Before the
Federal Communications Commission
Washington, D.C. 20554

In the matter of)	
)	
ARINC Incorporated)	File Nos. SES-LIC-20030910-01261
)	SES-AMD-20031223-01860
Application for Blanket Authority for Operation)	
of Up to One Thousand Technically Identical)	
Ku-Band Transmit/Receive Airborne Mobile)	
Stations Aboard Aircraft Operating in the)	
United States and Adjacent Waters)	
)	
)	
)	
)	
)

ORDER AND AUTHORIZATION

Adopted: April 5, 2005

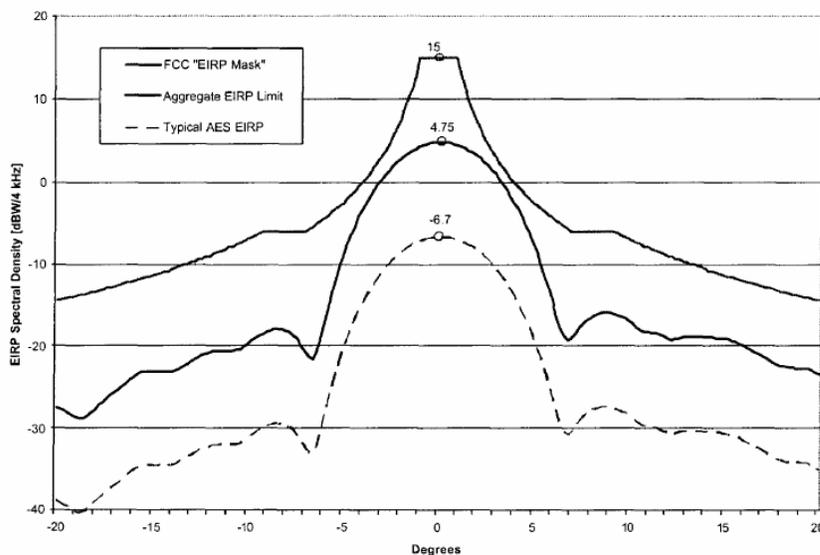
24. The SKYLink System operates with an Aloha/CDMA access protocol that allows multiple simultaneous co-frequency AES transmissions, relying on code differentiation to minimize self-interference. Because SKYLink AES antennas are not large enough to suppress side-lobe gain to the extent necessary for conformance with the limits in Section 25.209(a)(1), ARINC proposes to compensate by limiting AES input power density to levels well below the -14 dBW/4kHz limit for routinely-authorized digital VSAT Earth stations. ARINC determined that if the aggregate input-power spectral density of simultaneously-transmitting co-frequency SKYLink AES terminals does not exceed -24.25 dBW/4kHz, the system’s aggregate uplink off-axis e.i.r.p. density will not exceed a one-dB margin below

the VSAT emission envelope at the worst-case angle, as depicted by the following diagram.³⁴

ARINC asserted in its application that the input power density into a single SKYLink AES terminal would never exceed -24.25 dBW/4kHz and that the aggregate input power density into simultaneously-transmitting SKYLink AES terminals would be kept below that level *almost* all the time, through dynamic network control of AES power, log-ins, and data transmission rates.³⁵ Specifically, ARINC estimated that with 214 SKYLink AES terminals logged in over one transponder the probability of aggregate earth-station on-axis e.i.r.p. density exceeding the -24.25 dBW/4 kHz level at any given point in time would be less than 0.001 percent.³⁶ ARINC asserted that the SKYLink NMS would authorize no more than 214 terminals to be logged in concurrently and therefore maintained that the system's aggregate off-axis e.i.r.p. would be within the VSAT emission envelope at least 99.999 percent of the time.³⁷

26. Boeing disputes ARINC’s probability estimate on several grounds. Boeing argues that the estimate is belied by statements in the SKYLink application regarding operation of a congestion-control algorithm that would reduce AES duty cycles in high-traffic situations. Specifically, Boeing points out that, as described, the congestion controller would intervene only if the number of simultaneous AES transmissions reaches a level at which, by ARINC’s admission, aggregate off-axis e.i.r.p. density would exceed the VSAT emission envelope one percent of the time. Hence, Boeing maintains that the SKYLink System is designed to limit the worst-case probability of exceeding the VSAT emission envelope to one percent, not 0.001 percent.⁴³ In response, ARINC asserts that it assumed for purposes of its Monte Carlo simulations that all terminals transmit at the maximum return-link data rate of 128 kbps and thus that the results demonstrate that its system will keep aggregate e.i.r.p. density within the VSAT emission envelope at least 99.999 percent of the time without relying on the congestion control algorithm.⁴⁴

27. Boeing also contends that ARINC’s repeated assertion, in its report on the Monte Carlo simulations, that the SKYLink System will comply with the VSAT emission envelope 99.999 percent of the time is inconsistent with representations in the SKYLink application and the coordination agreement with SES and PanAmSat that aggregate earth-station off-axis e.i.r.p. density would be kept within a one-dB margin *below* the envelope 99.999 percent of the time.⁴⁵ In response, ARINC says that it refrained from mentioning the one-dB margin when discussing the simulations simply because Boeing’s preceding

30. The probability specification for the SKYLink System requires adherence to the VSAT emission envelope to a substantially greater extent than is required by the blanket waiver for random-access VSAT systems.⁵² Yet, due to the use of spread-spectrum CDMA multiplexing for SKYLink return-link transmissions, peak aggregate off-axis e.i.r.p. density from multiple SKYLink AES operation will be substantially lower than a typical random-access VSAT network would generate if operating with the same probability of exceeding the VSAT emission envelope and much lower than the eight-dB-above-the-envelope limit that the Commission has proposed for contention-access VSAT systems that exceed the limit 0.001 percent of the time. We therefore conclude that SKYLink operation pursuant to the terms of the conditional authorization granted herein, pending adoption of service rules for Ku-Band AMSS, will not significantly increase the risk of harmful interference.

32. We need not determine here whether keeping the aggregate off-axis e.i.r.p. density of SKYLink uplink transmission within a one-dB margin below the VSAT emission envelope 99.999 percent of the time is necessary to prevent harmful interference. The authorization granted here requires ARINC to operate in compliance with that restriction because ARINC has represented that that is what it will do. Although it might be inferred from certain statements in its pleadings that ARINC does not intend to ensure compliance with the 99.999% probability specification under all foreseeable circumstances, we do not construe the statements in that way because any such intention would be inconsistent with unequivocal representations in the SKYLink application. Nor do we construe any other specification in the application as overriding the commitment to keep the probability of exceeding the one-dB aggregate off-axis e.i.r.p. margin within 0.001 percent. Thus, for instance, if allowing 214 AES terminals to be logged in at the same time⁵³ would be inconsistent with that commitment, the authorization granted here does not permit it.⁵⁴
